S E R V I C E N O T E

37714A PDH/SDH/Jitter Test Set

Mechanical Shock can disconnect output cable from PDH Tx Assembly

Figure 1 : Showing Preferred Route for cable A7 J4 to Module Front Panel

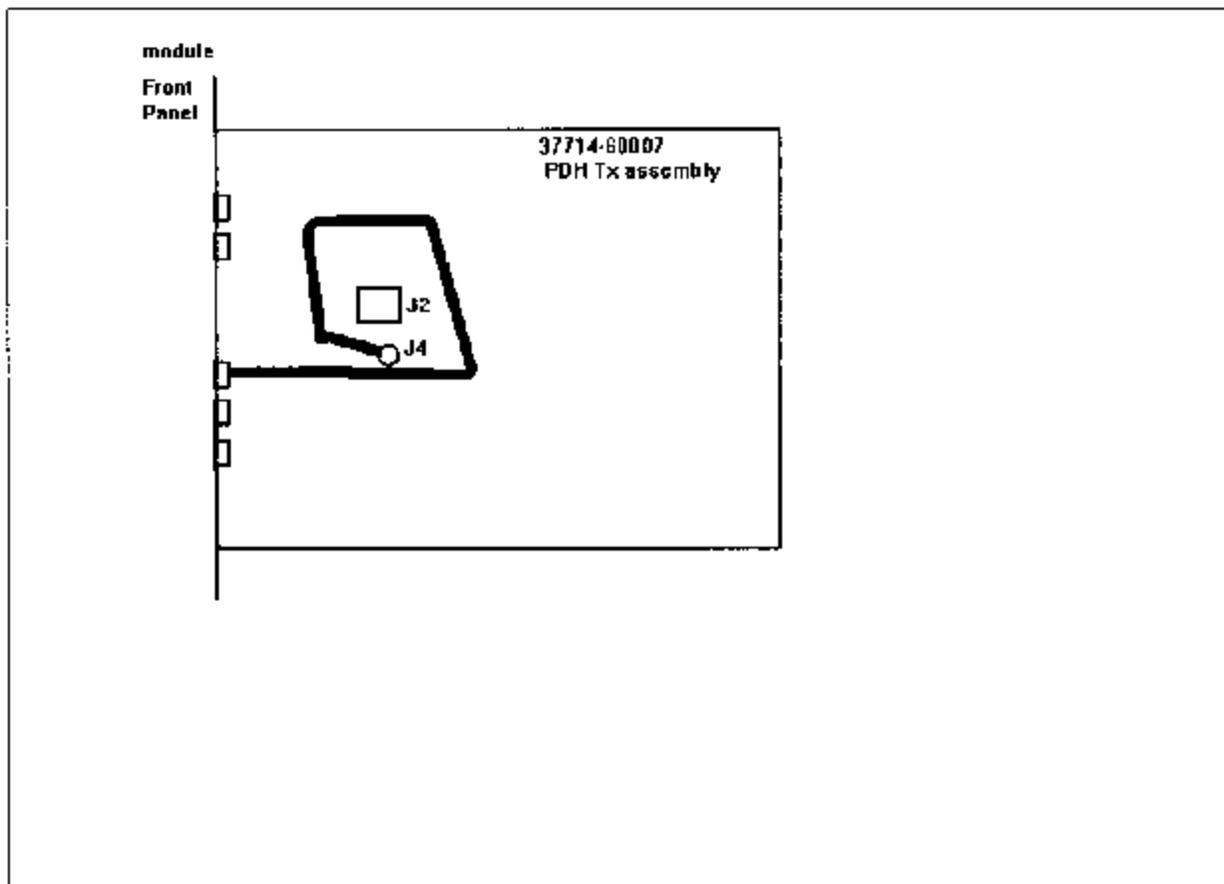
This is caused by the connector and cable which carries this signal to the PDH Tx/Rx Module front panel becoming detached from the socket on the PDH Tx Board Assembly.

If any of these units is encountered (see above for list of serial numbers) the hardware modification described below should be performed. This involves removing the PDH Module from the instrument, then separating the Tx and Rx board assemblies to allow access to cable A7 J4. This cable is then re-routed in such a way as to avoid relay A7 K2 which is responsible for separating the cable plug from J4 when the cable is turned.

7. On the PDH Module, remove the four screws attaching the Rx Board Assembly to the Tx board Assembly (the Tx board is identified as 37714-60007).
8. Remove the two spacers fitted between the Rx Board and the front metalwork.
9. Separate the two boards to allow access to the cables and connectors on the PDH transmitter Assembly.
10. Locate the coaxial socket A7 J4 and re-route the plug-in connector and cable leading from this socket to the Front Panel as shown in Figure 1.
11. Re-attach the two board assemblies with the four screws and two spacers.
12. Fit the PDH assembly back into the instrument and re-assemble as a reversal of the above procedure.
13. Replace the outer cabinet sleeve, optical module shields and rear panel feet - this is a reversal of the removal procedure.
